STAFF REVIEW AND RECOMMENDATIONS
PUBLIC HEARING
MARCH 16, 2023

PRELIMINARY PLAT: HIDDEN ACRES
LEGAL DESCRIPTION: SEC 24, T18N, R01E, SEWARD MERIDIAN AK
PETITIONERS: ROCKY POINT DEVELOPMENT, LLC
SURVEYOR/ENGINEER: KEYSTONE SURVEYING
ACRES: 24.20 ± PARCELS: 5
REVIEWED BY: MATTHEW GODDARD CASE #: 2023-006

REQUEST: The request is to create five lots from Tract A, Spring Hill, Plat # 2022-88 to be known as **HIDDEN ACRES**, containing 24.20 acres +/- . The petitioner is requesting a variance to MSB 43.20.320 Frontage for proposed Lot 5. The property is located south and east of N. Trunk Road, and directly west of N. Palmer Fishhook Road; within the SE ¼ Section 24, Township 18 North, Range 01 East, Seward Meridian, Alaska.

EXHIBIT J-5

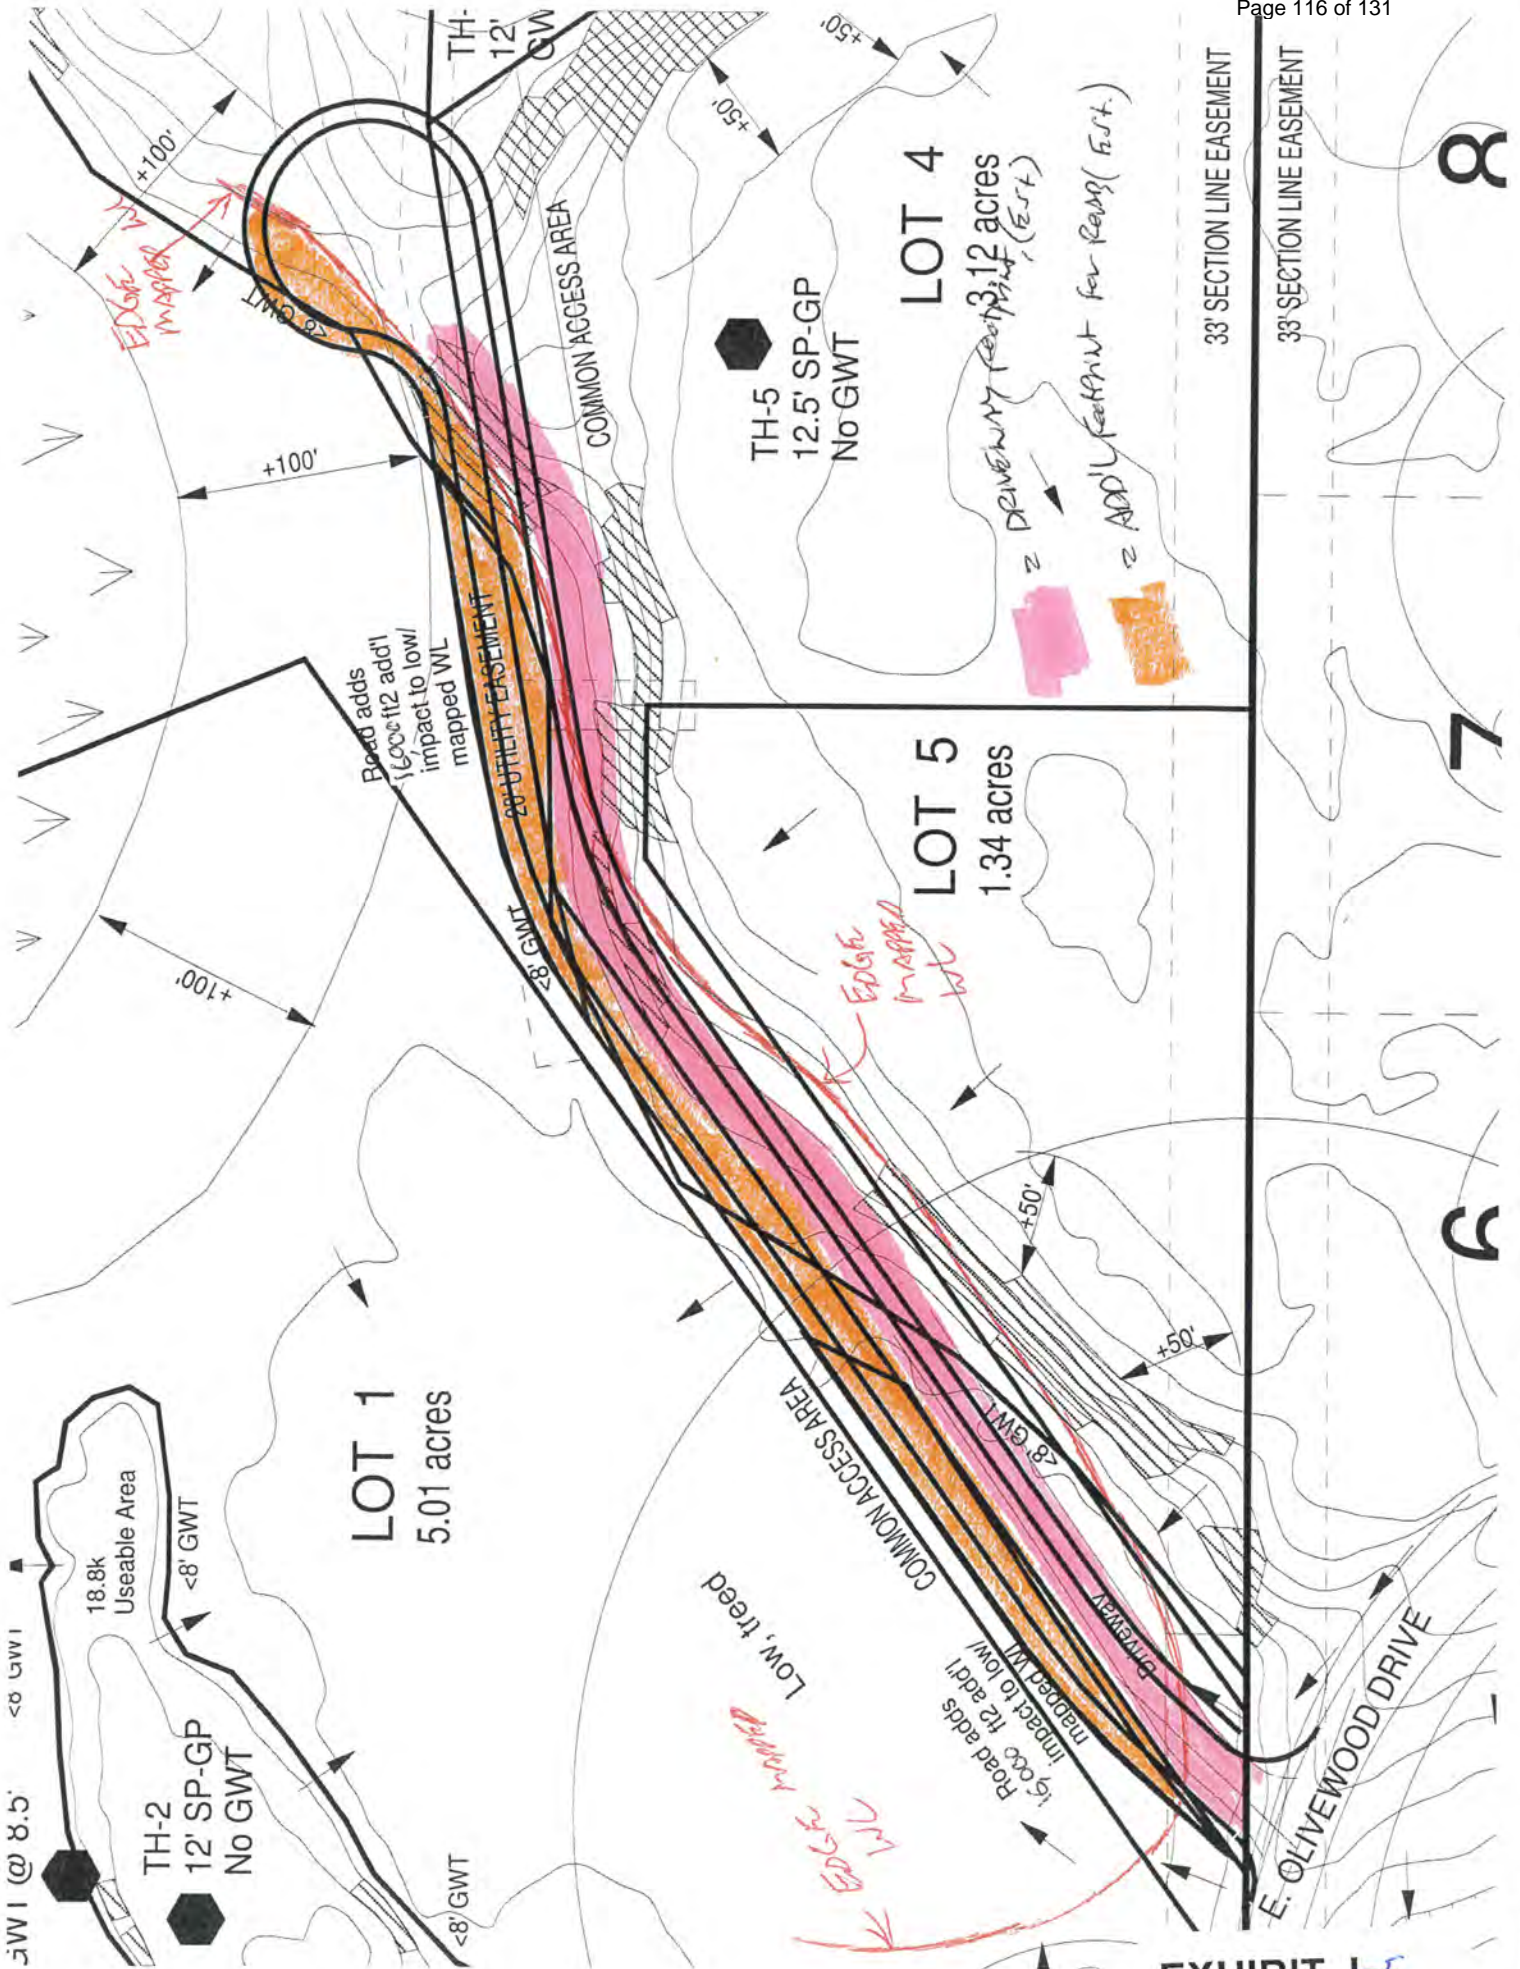
“Variance: DPW does not support approval of the variance based on the information that has been provided. We have requested from the petitioner supporting information for the claim in the variance request that constructing a borough standard road to access the lots would impact the wetlands. A plan drawing showing the extents of wetlands and the footprint of a borough standard road vs the footprint of a borough standard driveway (as proposed) would be sufficient.” See attached sketches. Using a similar alignment, it is clear that substantially more mapped wetlands area would be affected by constructing either a short CDS road, or a longer road extending back into the property to a CDS. There are several reasons why: 1 Road and CDS footprints are wider than driveways, generally with wider foreslopes. 2 Roads have vertical and horizontal limits which are far more restrictive than driveways; this limits the ability of a road to form fit to the existing surface within the easement or ROW. 3 Roads typically are centered within the area, while a driveway need only fit within the area. In this particular case, I drew a typical short CDS and estimated the minimum footprint that would be required. Then that footprint was compared to the footprint of the existing, survey located driveway edge, including an estimation of the foreslopes on the northwest side. The difference for these options was approximately 6900 ft², with the CDS taking up far more area. Using the same methodology for a longer road and CDS, there was an area of increased use of roughly 16,000 ft²; note that the portion of the driveway past about 300’ is estimated, not surveyed. See the attached file with 2 sketches. If a road or short CDS were to be constructed, it is likely the project could support substantially more than 5 lots.

“Sight Distance: Multiple conditions exist (vertical & horizontal alignment, vegetation, etc.) which potentially limit sight distance along Olivewood Drive from the proposed driveway. DPW does not support approval of the proposed plat, which will confine access to the five proposed lots to a single point, without verification that adequate sight distance exists (or can exist with additional clearing within the ROW). We have requested the petitioner provide sight distance measurements in accordance with the driveway code (MSB 11.12.050(A)(9)).” We visited the site earlier today and positioned a Subaru with a 3.5’ target on the windshield center as approaching from both sides. Photos were taken from a measured 3.5’ height, 17’ back from the Olivewood Drive westbound lane center. The 2 photos are attached. In the case of SD to the left, the vehicle is positioned with the target at 280’. To the right, the target is at 240’. Based on our measurements and observations, sight distance is adequate, which was also our perception operating into and out of the driveway in question.

“Access/ADT: According to the ADT estimate, Birch Forest Drive from Trunk Road to Oakwood Drive is warranted to be Residential Subcollector. It is currently classified as Residential. The petitioner’s engineer should provide documentation certifying Birch Forest Drive meets Residential Subcollector standard.” In driving this section the road readily meets basic RSC requirements for grade and curvatures. The road is paved just over 20’ in width with adequate shoulders. Most of the section is a fill construction, with well adequate

ditches and snow storage. Based on past experiences, the intersection with N Trunk Road meets ADOT standards for approach intersections. Sight distance was essentially unrestricted and more than adequate at each of the 3 intersections, which all have minimal grades. Based on our wintertime observations and measurements, the road would meet RSC standards as it exists. Based on the lot count analysis, the additional 5 new lots will comprise only 5/79 or 6% of the traffic at Trunk, and 5/38 or 13% at the beginning of the section in question. Whatever the existing certification, more than half of the road section in question appears to already be serving in a RSC capacity, providing access for more than 40 existing lots.

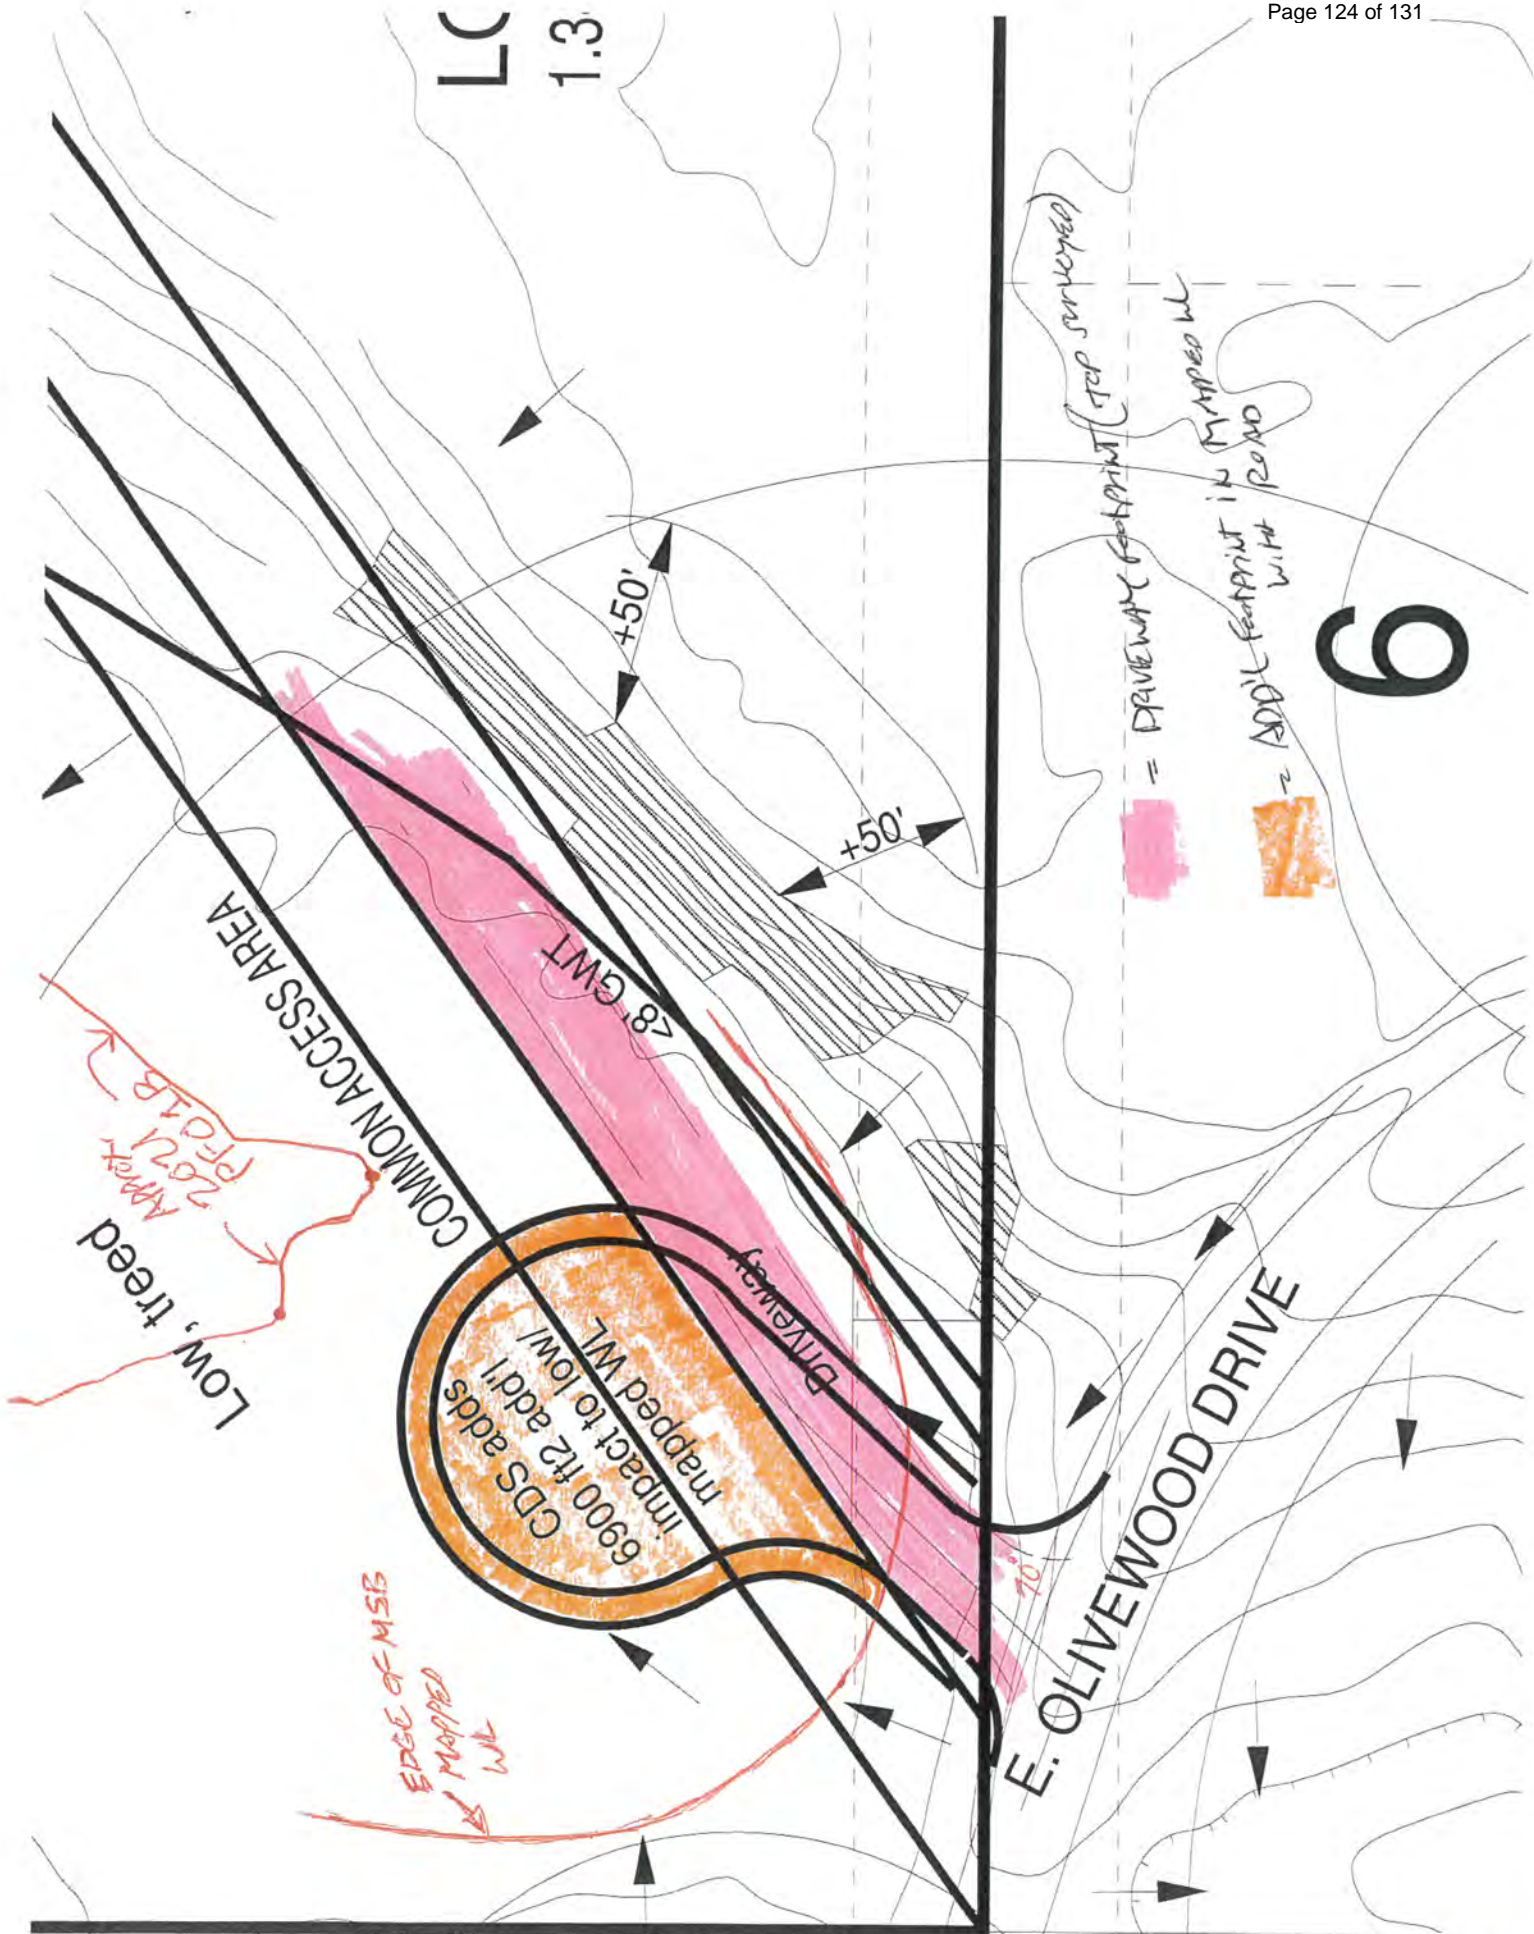
“Variance: DPW does not support approval of the variance based on the information that has been provided. We have requested from the petitioner supporting information for the claim in the variance request that constructing a borough standard road to access the lots would impact the wetlands. A plan drawing showing the extents of wetlands and the footprint of a borough standard road vs the footprint of a borough standard driveway (as proposed) would be sufficient.” See attached sketches. Using a similar alignment, it is clear that substantially more mapped wetlands area would be affected by constructing either a short CDS road, or a longer road extending back into the property to a CDS. There are several reasons why: 1 Road and CDS footprints are wider than driveways, generally with wider foreslopes. 2 Roads have vertical and horizontal limits which are far more restrictive than driveways; this limits the ability of a road to form fit to the existing surface within the easement or ROW. 3 Roads typically are centered within the area, while a driveway need only fit within the area. In this particular case, I drew a typical short CDS and estimated the minimum footprint that would be required. Then that footprint was compared to the footprint of the existing, survey located driveway edge, including an estimation of the foreslopes on the northwest side. The difference for these options was approximately 6900 ft², with the CDS taking up far more area. Using the same methodology for a longer road and CDS, there was an area of increased use of roughly 16,000 ft²; note that the portion of the driveway past about 300’ is estimated, not surveyed. See the attached file with 2 sketches. If a road or short CDS were to be constructed, it is likely the project could support substantially more than 5 lots.

“Sight Distance: Multiple conditions exist (vertical & horizontal alignment, vegetation, etc.) which potentially limit sight distance along Olivewood Drive from the proposed driveway. DPW does not support approval of the proposed plat, which will confine access to the five proposed lots to a single point, without verification that adequate sight distance exists (or can exist with additional clearing within the ROW). We have requested the petitioner provide sight distance measurements in accordance with the driveway code (MSB 11.12.050(A)(9)).” We visited the site earlier today and positioned a Subaru with a 3.5’ target on the windshield center as approaching from both sides. Photos were taken from a measured 3.5’ height, 17’ back from the Olivewood Drive westbound lane center. The 2 photos are attached. In the case of SD to the left, the vehicle is positioned with the target at 280’. To the right, the target is at 240’. Based on our measurements and observations, sight distance is adequate, which was also our perception operating into and out of the driveway in question.

“Access/ADT: According to the ADT estimate, Birch Forest Drive from Trunk Road to Oakwood Drive is warranted to be Residential Subcollector. It is currently classified as Residential. The petitioner’s engineer should provide documentation certifying Birch Forest Drive meets Residential Subcollector standard.” In driving this section the road readily meets basic RSC requirements for grade and curvatures. The road is paved just over 20’ in width with adequate shoulders. Most of the section is a fill construction, with well adequate ditches and snow storage. Based on past experiences, the intersection with N Trunk Road meets ADOT standards for approach intersections. Sight distance was essentially unrestricted and more than adequate at each of the 3 intersections, which all have minimal grades. Based on our wintertime observations and measurements, the road would meet RSC standards as it exists. Based on the lot count analysis, the additional 5 new lots will comprise only 5/79 or 6% of the traffic at Trunk, and 5/38 or 13% at the beginning of the section in question. Whatever the existing certification, more than half of the road section in question appears to already be serving in a RSC capacity, providing access for more than 40 existing lots.
